CONSTRUCTION PLANS FOR

NOR ESTE MANOR SUBDIVISION

DRAINAGE, GRADING, PAVING AND UTILITY
IMPROVEMENTS

NOTE:
SHEETS AFFECTED BY CHANGE ORDER #1
AS INDICATED

TITLE: **NOR ESTE MANOR**
GRADING PLAN

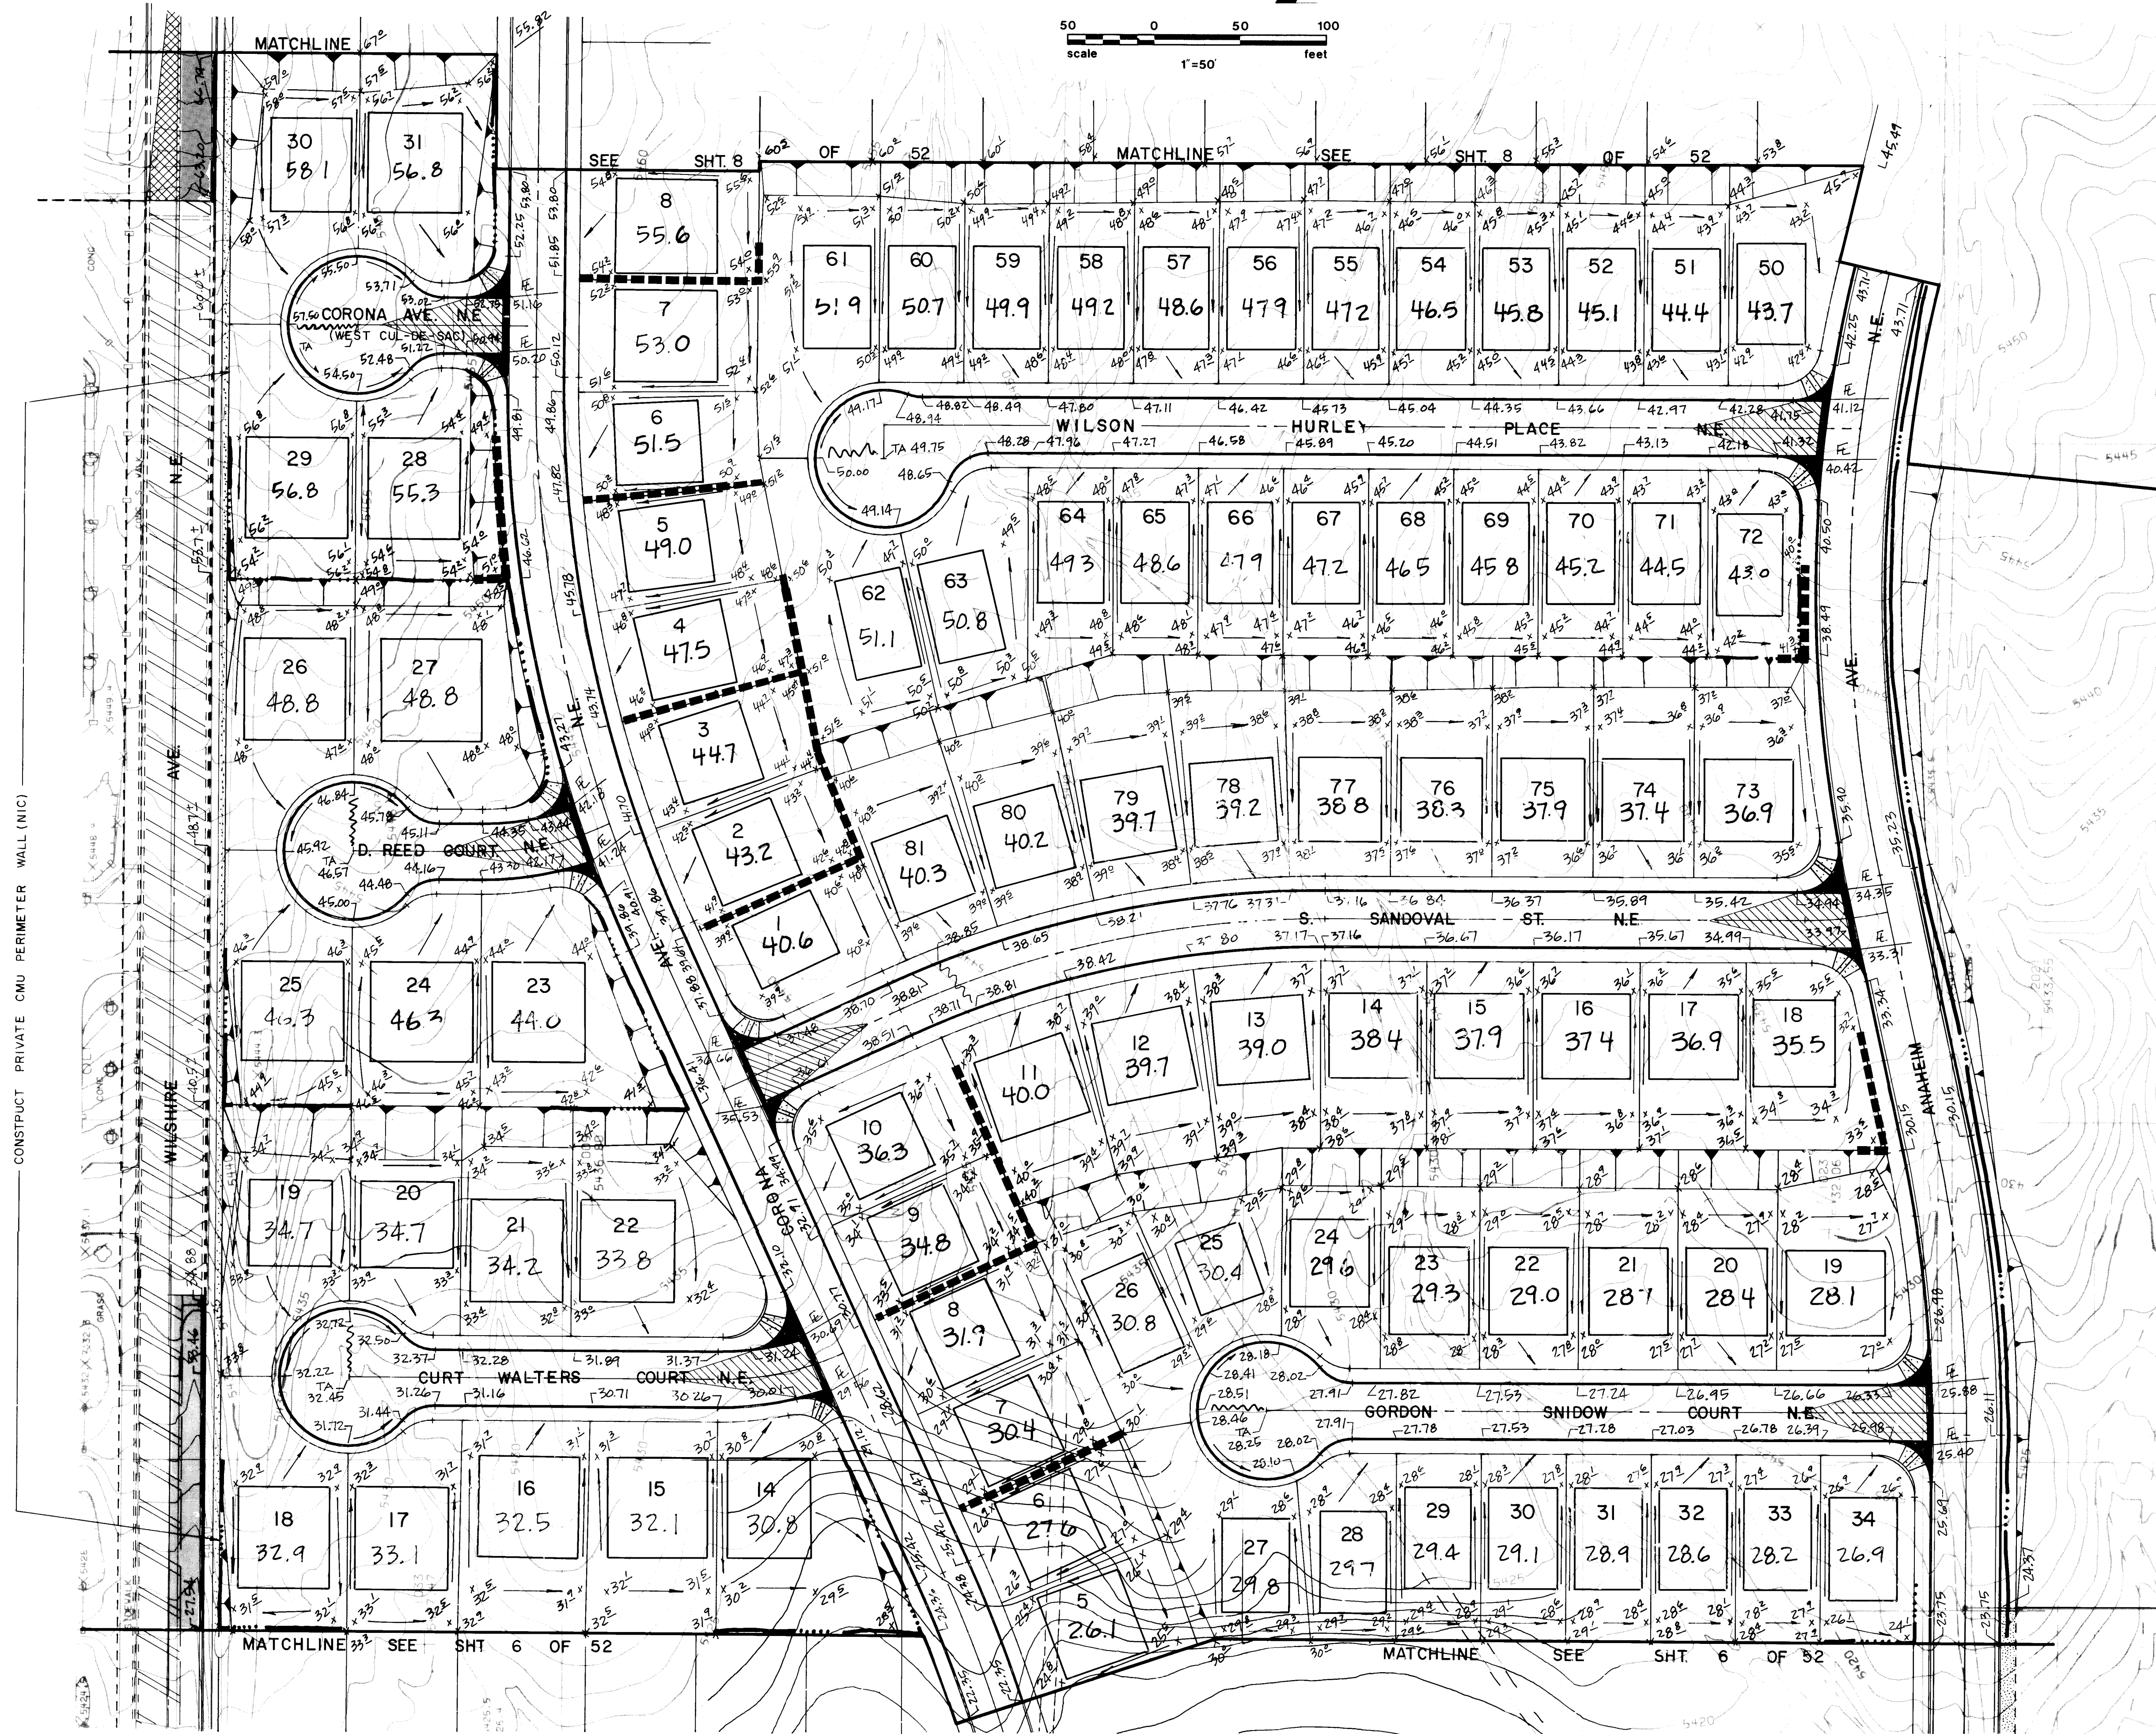
REVISIONS CHANGE ORDER NO. 1
GRADING OF BLOCK C, LOTS 1-5, 10-13
BLOCK D
BLOCK B
BLOCK A, LOTS 1-7
TRACT A

TITLE: NOR ESTE MANOR GRADING PLAN

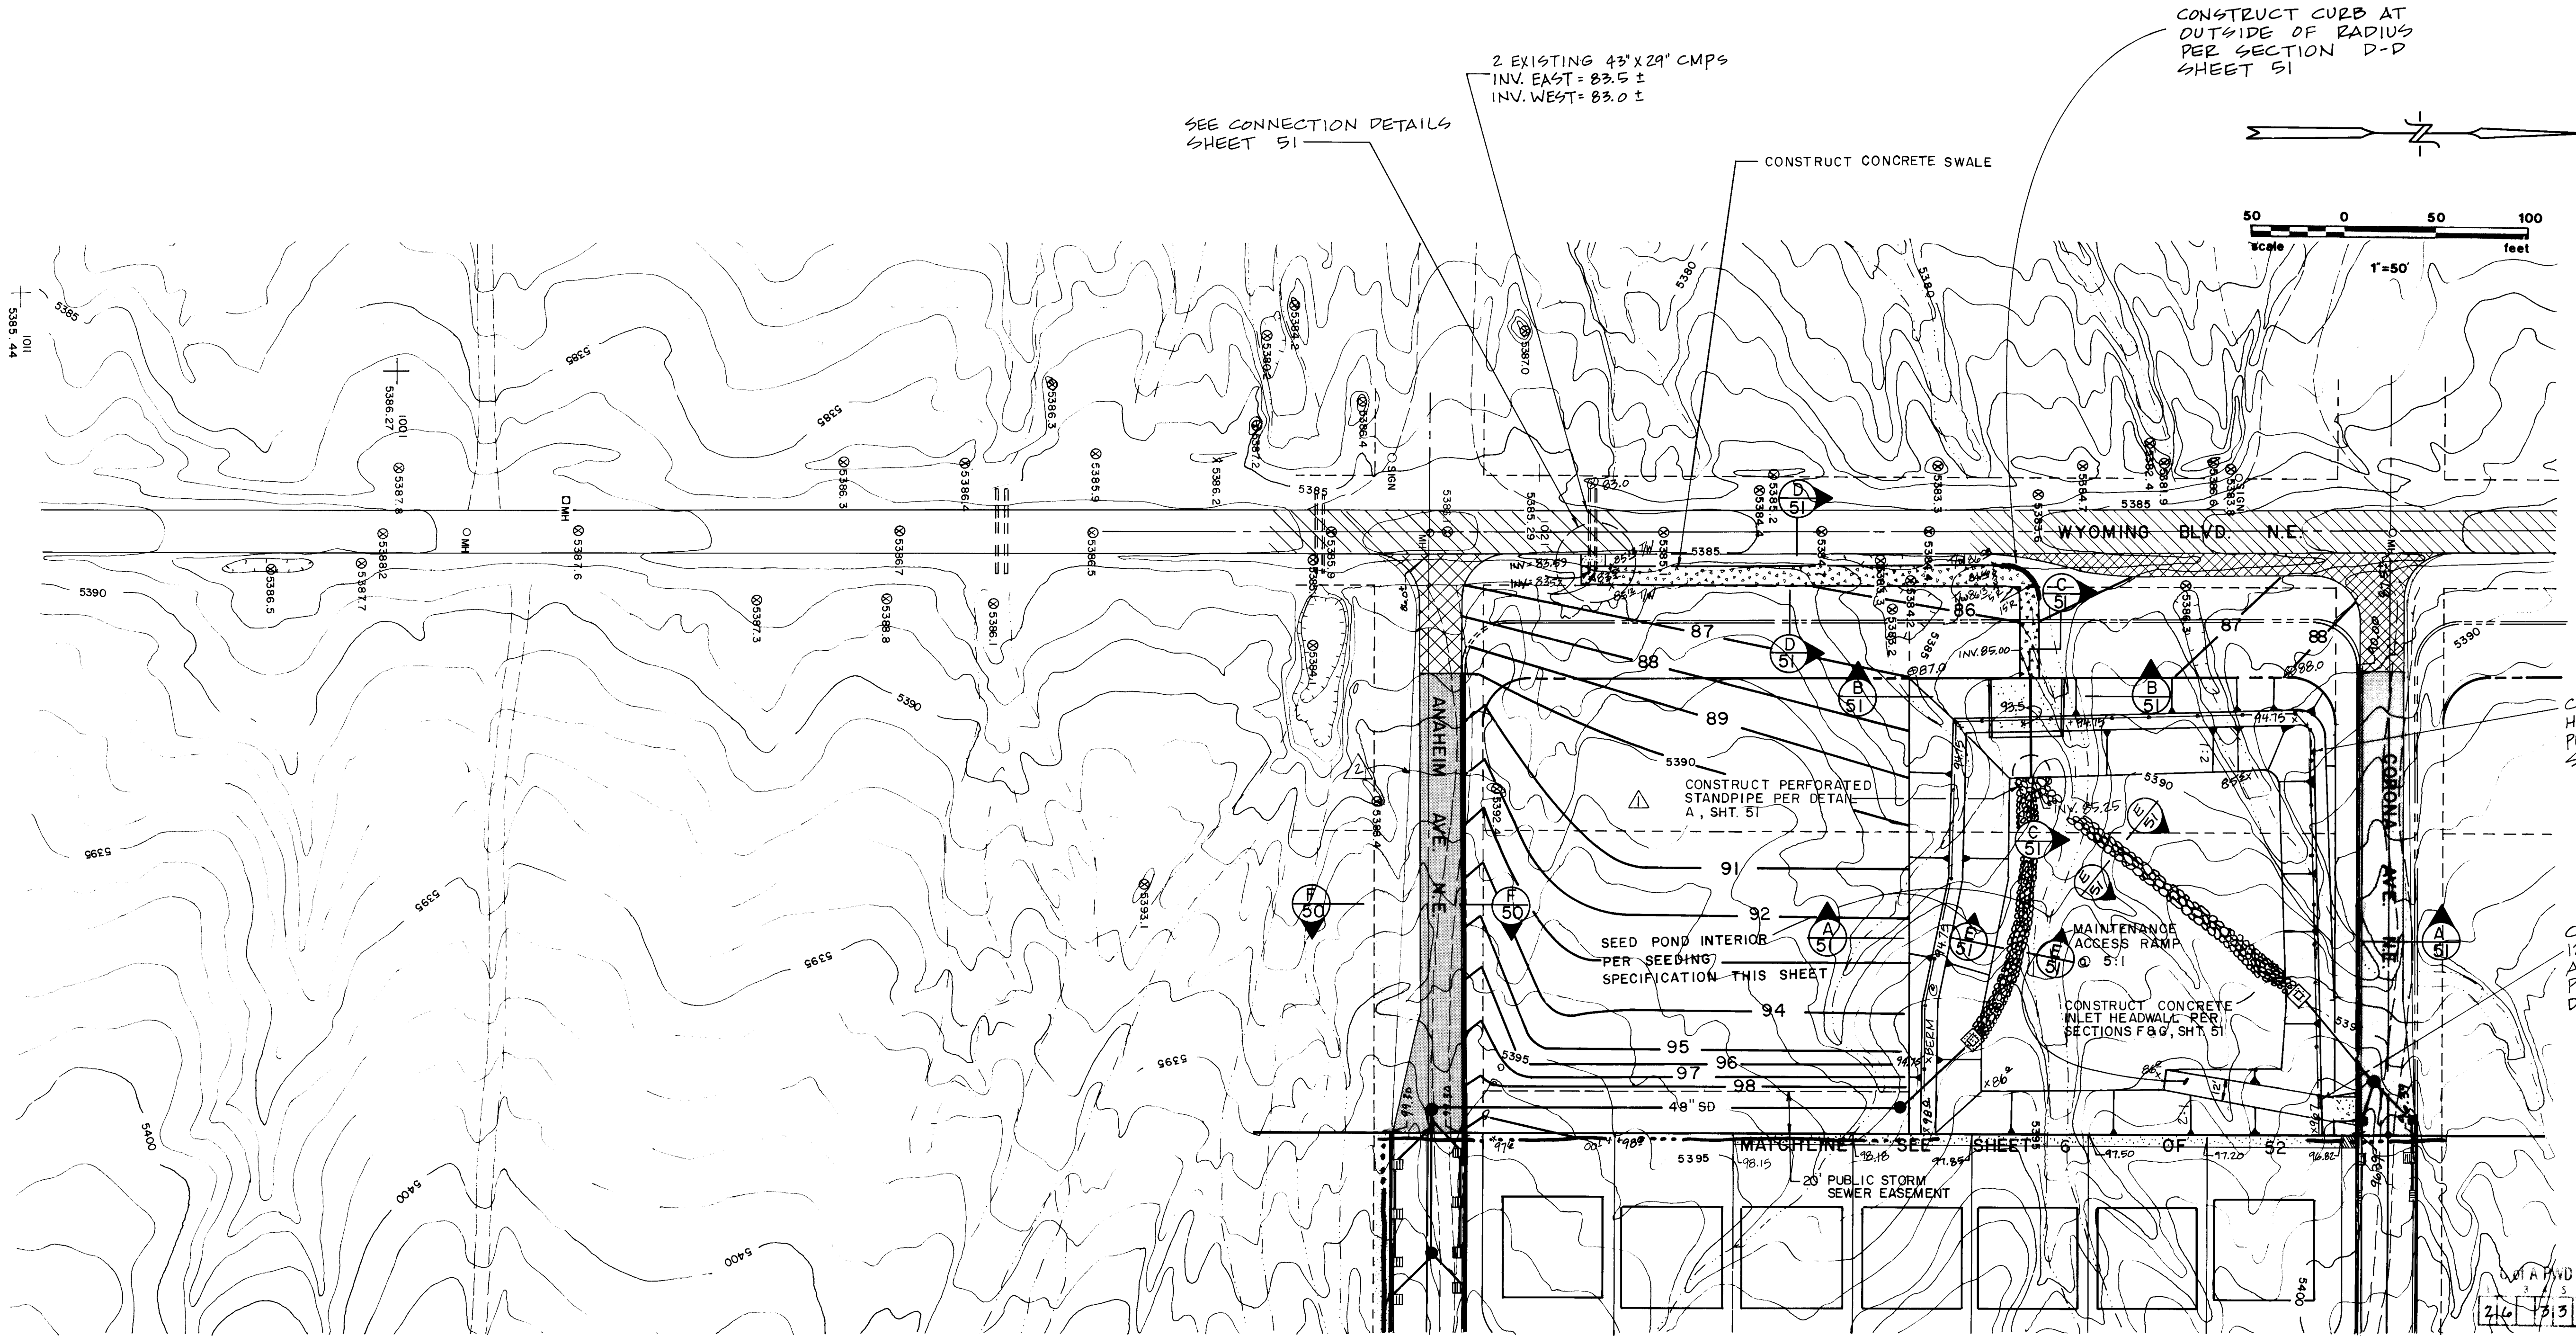
ADD 48" STORM SEWER OUTFALL LINE FROM ANAHEIM TO DETENTION POND

ADD PERMANENT PAVING TO ANAHEIM
